- A0 TITLE SHEET
- A1 BASEMENT PLAN ELEV. 'A' & 'B'
- A2 GROUND FLOOR ELEV. 'A'
- A3 SECOND FLOOR ELEV. 'A'
- A4 PARTIAL ALT. KITCHEN LAYOUT
- A5 GROUND FLOOR ELEV. 'B'
- A6 SECOND FLOOR ELEV. 'B'
- A7 FRONT ELEVATION 'A'
- ROOF PLAN ELEV 'A'
- A8 RIGHT SIDE ELEVATION 'A'
- A9 REAR ELEVATION 'A' & 'B'
- A10 LEFT SIDE ELEVATION 'A'
- A11 FRONT ELEVATION 'B'
- ROOF PLAN ELEV 'B'
- A12 RIGHT SIDE ELEVATION 'B'
- A13 LEFT SIDE ELEVATION 'B'
- D1 CONSTRUCTION NOTES
- D2 CONSTRUCTION NOTES
- D3 CONSTRUCTION NOTES

Tice River Homes Legacy

model
36-03

project #
17052

BASEMENT PLAN ELEV. 'A' & 'B'

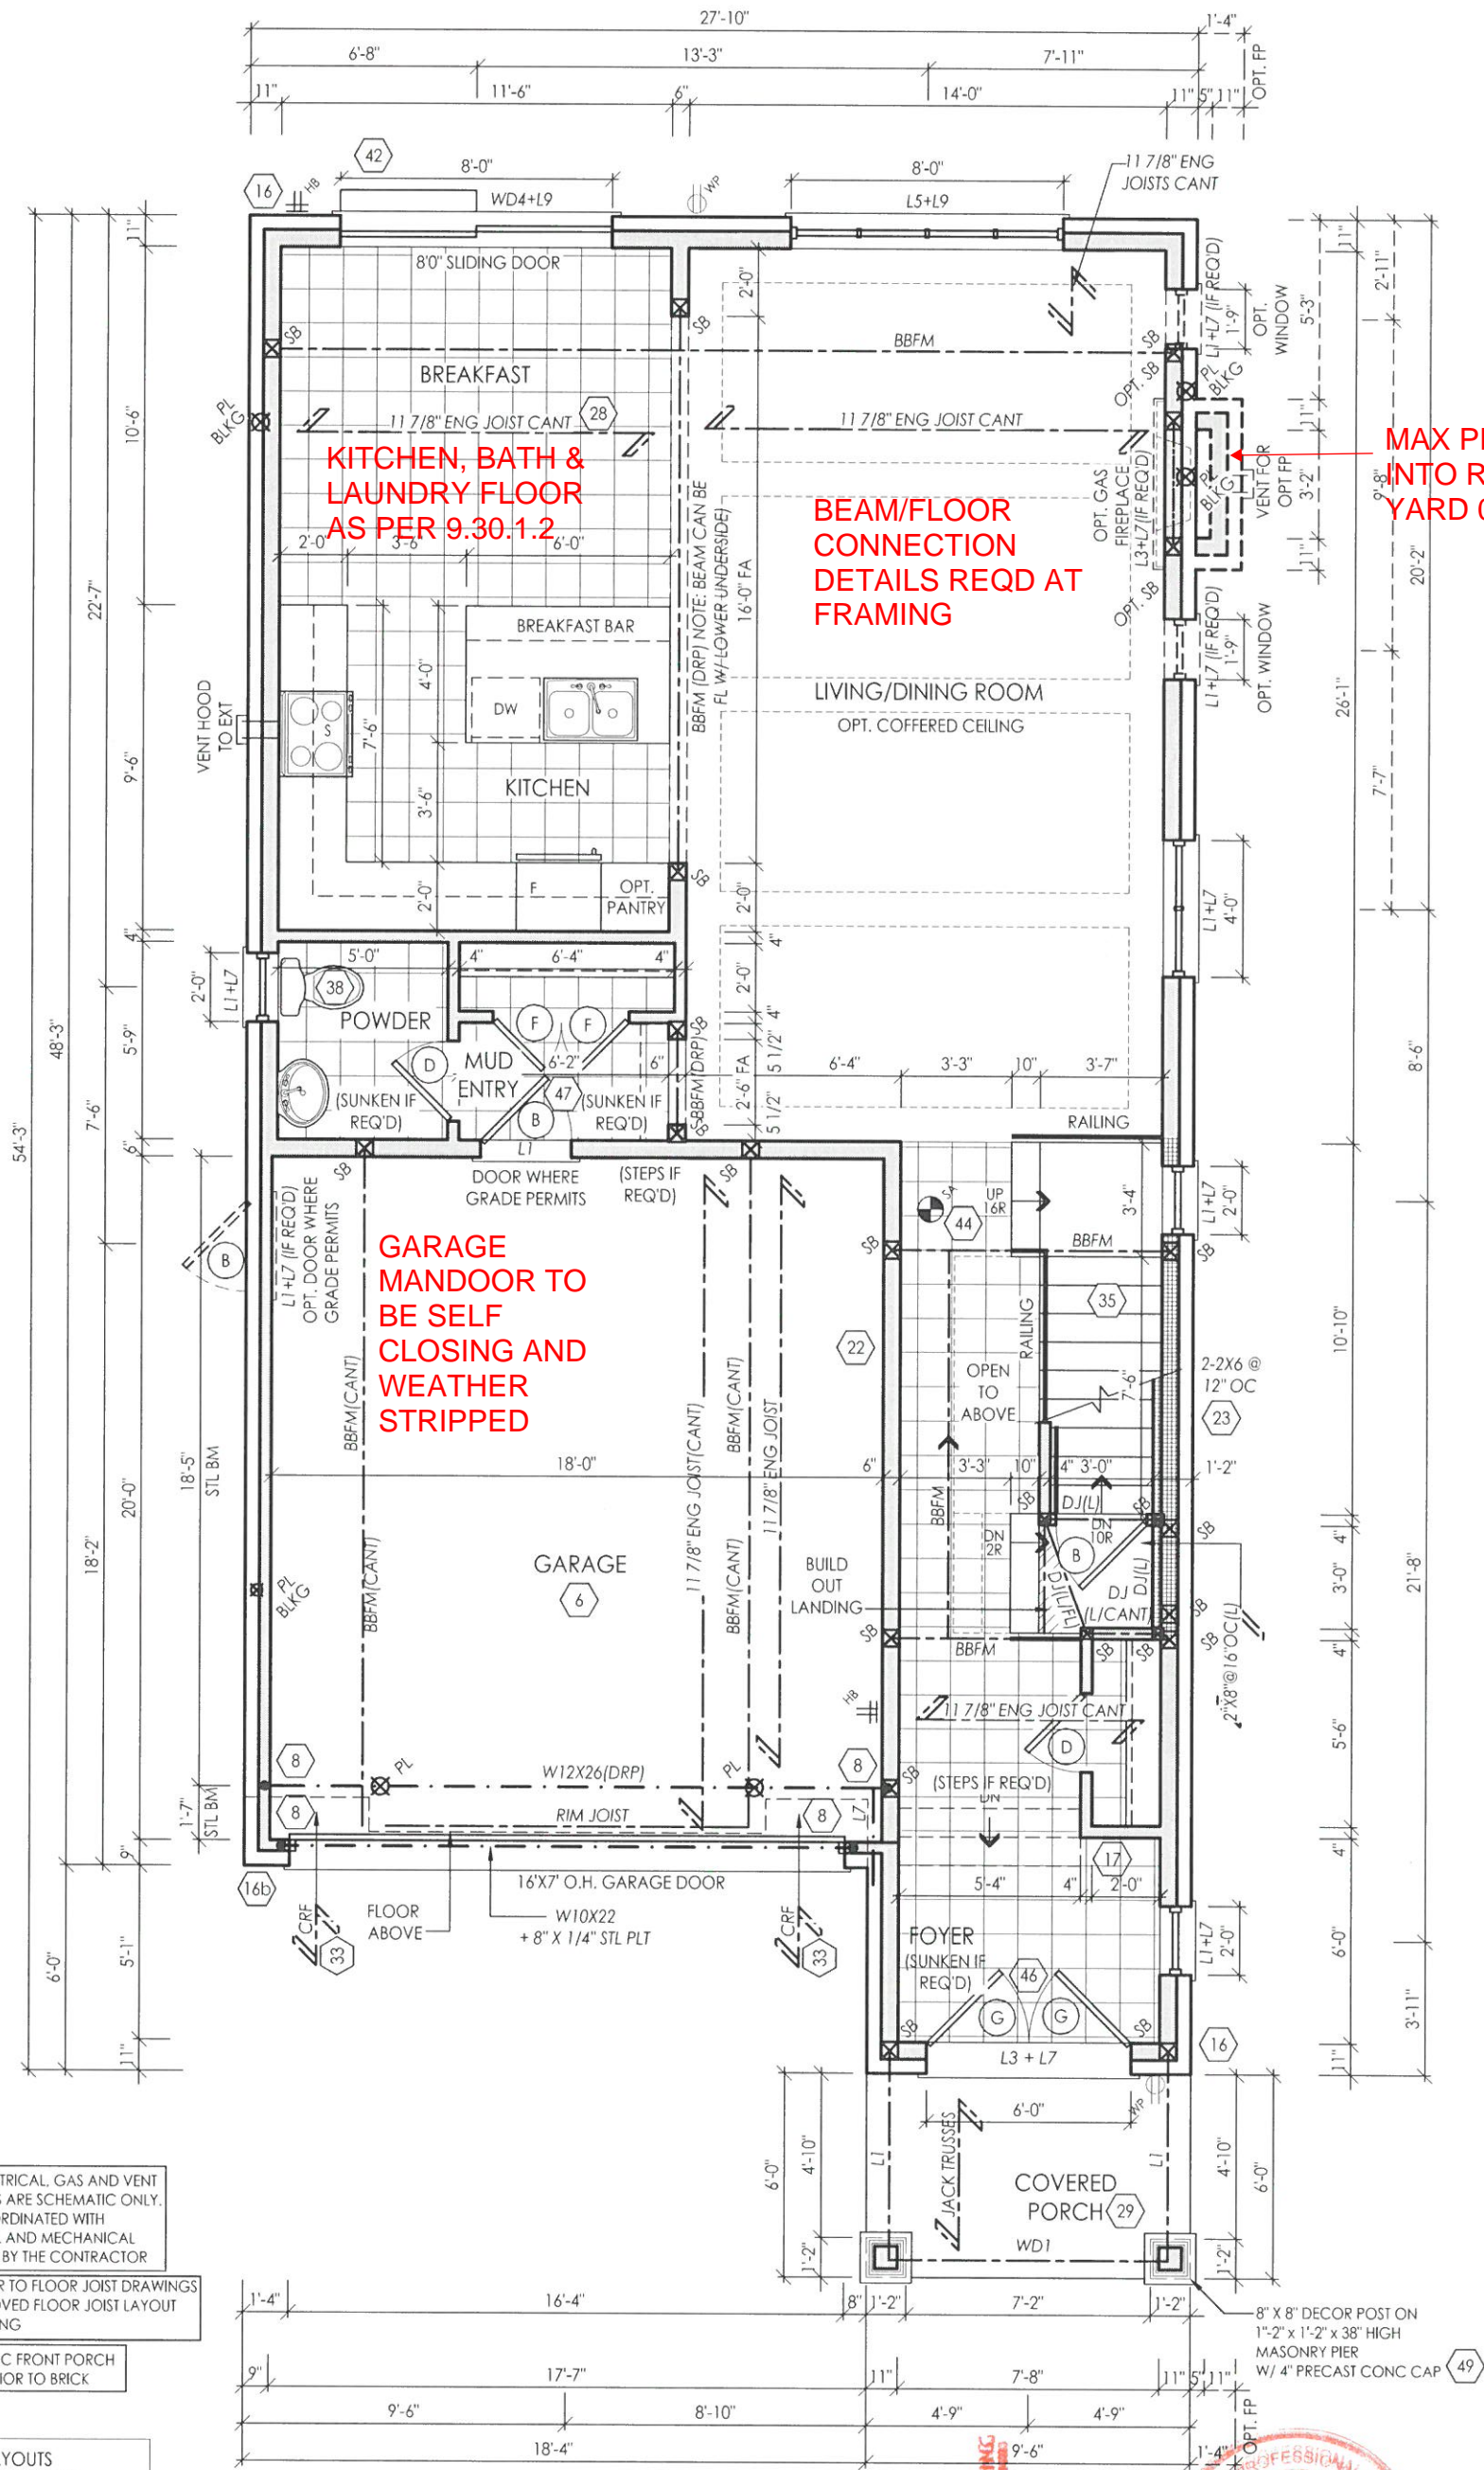
**BASEMENT AIR BARRIER
SUMP LIDS, JOINTS AT
INTERSECTIONS AND ALL
PENETRATIONS OF SLAB
MUST BE SEALED TO
PREVENT AIR LEAKAGE**

GROUND FLOOR ELEV. 'B'

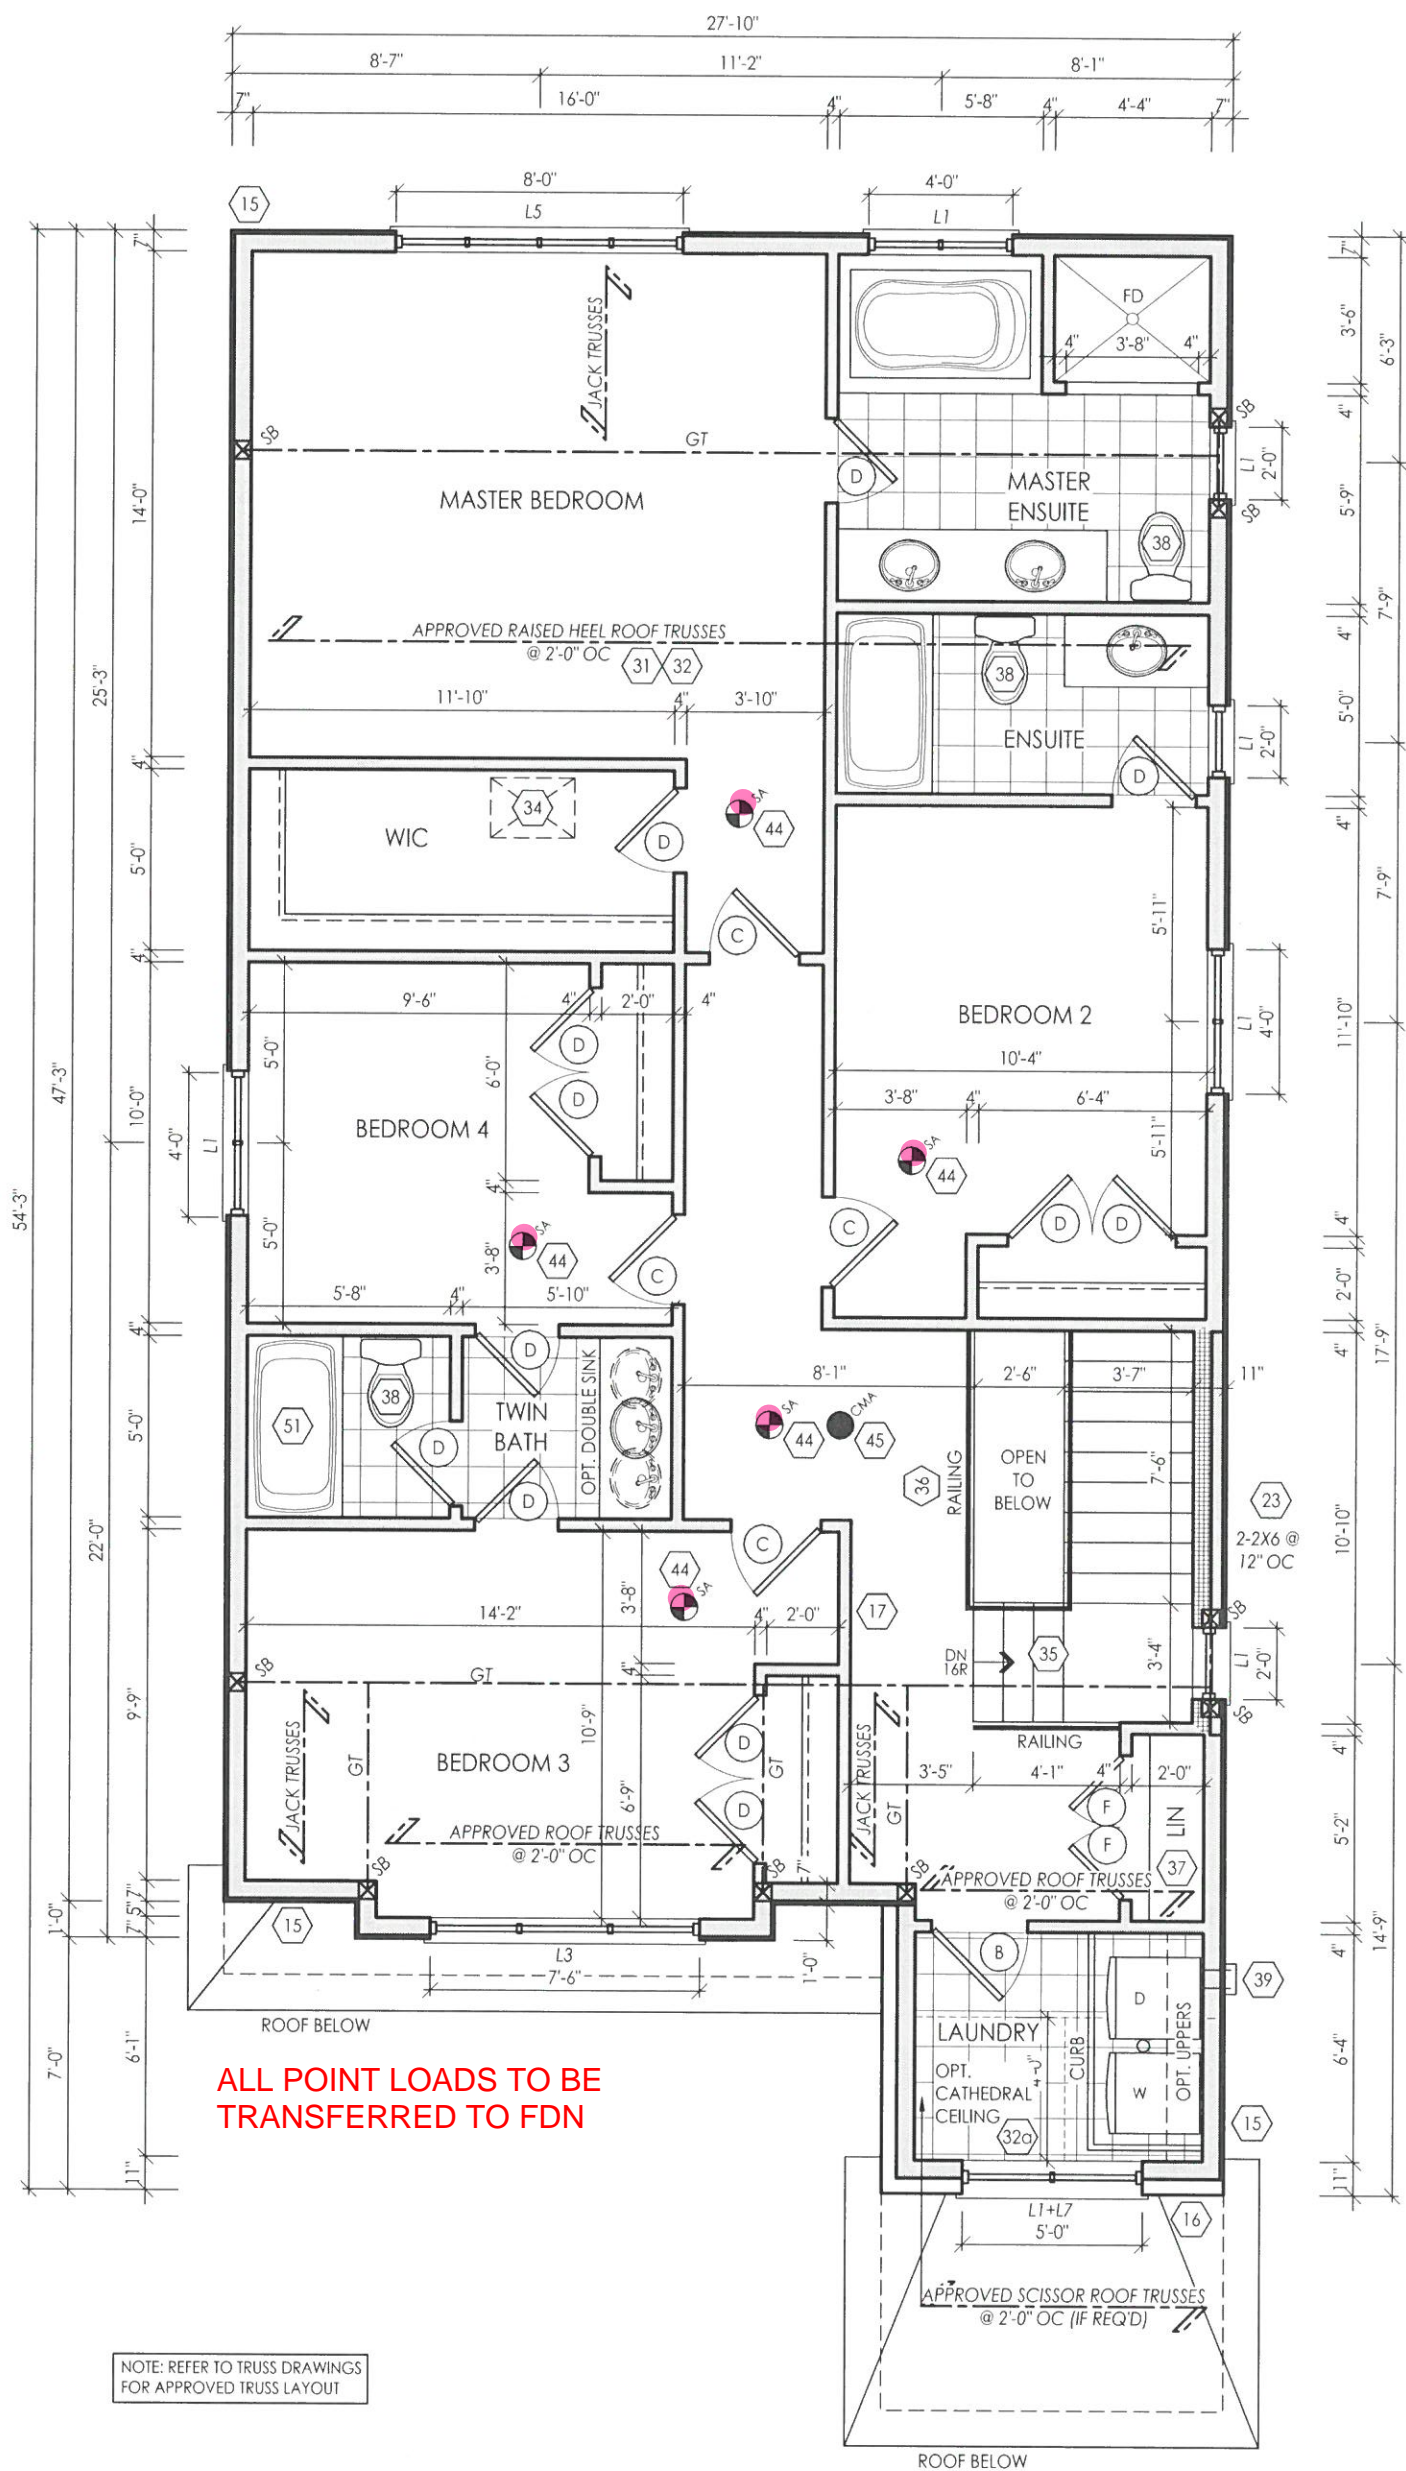
BEAM AND LINTEL
SIZES TO BE NOTED ON
FUTURE PLANS

LINTEL PACKAGE AND ENGINEERED BEAM
DETAILS TO BE SUBMITTED PRIOR TO
FRAMING INSPECTION

page: **A6**

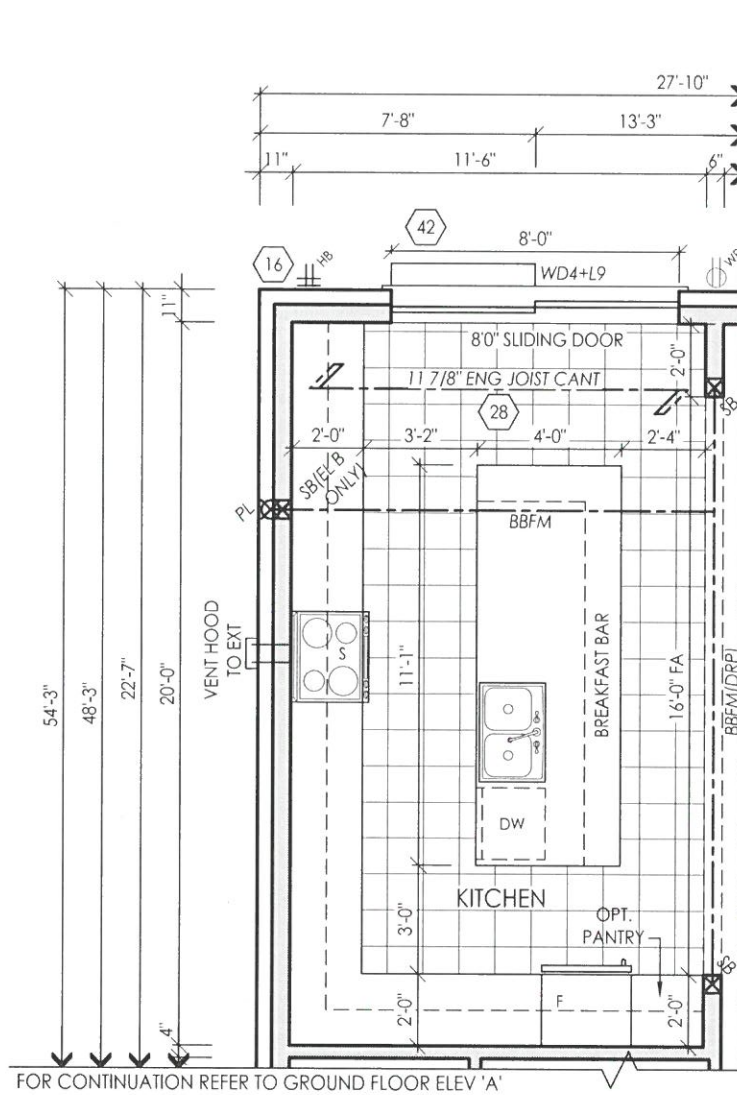
ENGINEERED FLOOR LAYOUT, TRUSSES AND LINTELS TO BE SUBMITTED PRIOR TO FRAMING. DESIGNER TO COMPLETE RESPONSIBILITY REVIEW FORM AND TO BE SUBMITTED WITH TRUSS, FLOOR AND LINTEL DOCUMENTS.

MAIN BATH TO HAVE GRAB BAR BLOCKING

WINDOW ON LANDING MUST BE HIGHER THAN 3' ABOVE OR ENGINEERING ON WINDOW OR GUARD REQD

ALL POINT LOADS TO BE TRANSFERRED TO FDN
